Well Name: BLUE KRAIT 23-14 FED	Well Location: T24S / R33E / SEC 23 / SESW / 32.196533 / -103.543538	County or Parish/State: LEA / NM
Well Number: 27H	Type of Well: OIL WELL	Allottee or Tribe Name:
Lease Number: NMLC063798	Unit or CA Name:	Unit or CA Number:
US Well Number: 3002546463	Well Status: Approved Application for Permit to Drill	Operator: DEVON ENERGY PRODUCTION COMPANY LP

Notice of Intent

Procedure Description: Devon Energy Production Company, L.P. respectfully requests approval for a break test variance. Please see the attached documentation.

PECOS DISTRICT DRILLING CONDITIONS OF APPROVAL

Variance Request

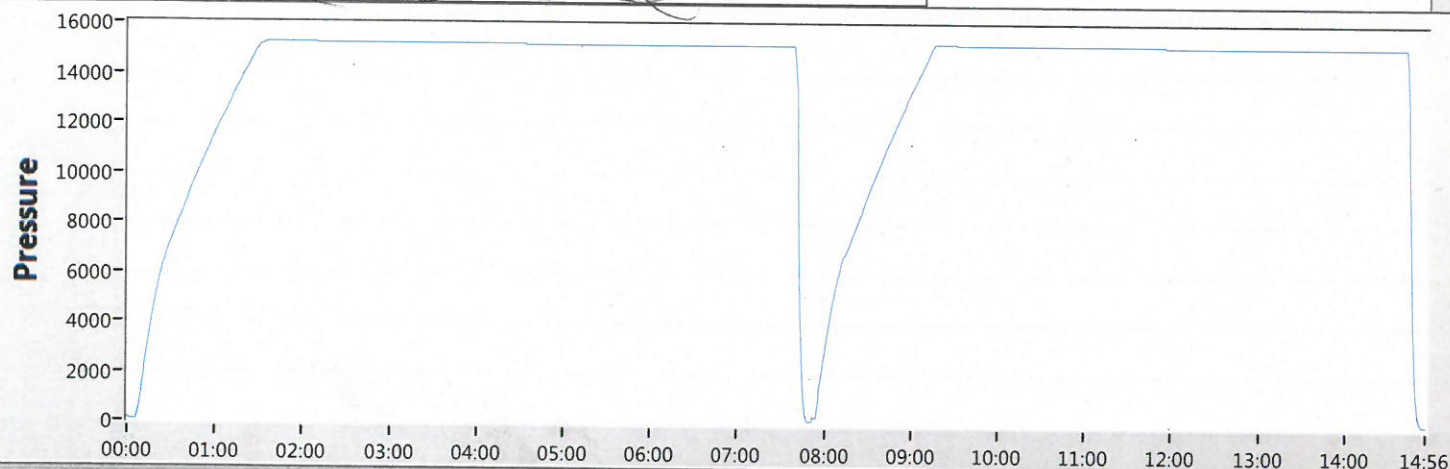
Devon Energy requests to only test BOP connection breaks after drilling out of surface casing and while skidding between wells which conforms to API Standard 53 and industry standards. This test will include the Top Pipe Rams, HCR, Kill Line Check Valve, QDC (quick disconnect to wellhead) and Shell of the 10M BOPE to 5M for 10 minutes. If a break to the flex hose that runs to the choke manifold is required due to repositioning from a skid, the HCR will remain open during the shell test to include that additional break. The variance only pertains to intermediate hole-sections and no deeper than the Bone Springs Formation where 5M BOP tests are required. The initial BOP test will follow OOGO2.III.A.2.i, and subsequent tests following a skid will only test connections that are broken. The annular preventer will be tested to 100% working pressure. This variance will meet or exceed OOGO2.III.A.2.i per the following: Devon Energy will perform a full BOP test per OOGO2.III.A.2.i before drilling out of the intermediate casing string(s) and starting the production hole, before starting any hole section that requires a 10M test, before the expiration of the allotted 14-days for 5M intermediate batch drilling or when the drilling rig is fully mobilized to a new well pad, whichever is sooner. We will utilize a 200' TVD tolerance between intermediate shoes as the cutoff for a full BOP test. The BLM will be contacted 4hrs prior to a BOPE test. The BLM will be notified if and when a well control event is encountered. Break test will be a 14 day interval and not a 30 day full BOPE test interval. If in the event break testing is not utilized, then a full BOPE test would be conducted.

1. Well Control Response:
 1. Primary barrier remains fluid
 2. In the event of an influx due to being underbalanced and after a realized gain or flow, the order of closing BOPE is as follows:
 - a) Annular first
 - b) If annular were to not hold, Upper pipe rams second (which were tested on the skid BOP test)
 - c) If the Upper Pipe Rams were to not hold, Lower Pipe Rams would be third

All Previous COAs Still Apply. Variance request procedure is approved as written, please see below general conditions for variance.

- BOPE Break Testing is ONLY permitted for 5M BOPE or less.
- BOPE Break Testing is NOT permitted to drilling the production hole section.
- While in transfer between wells, the BOPE shall be secured by the hydraulic carrier or cradle.
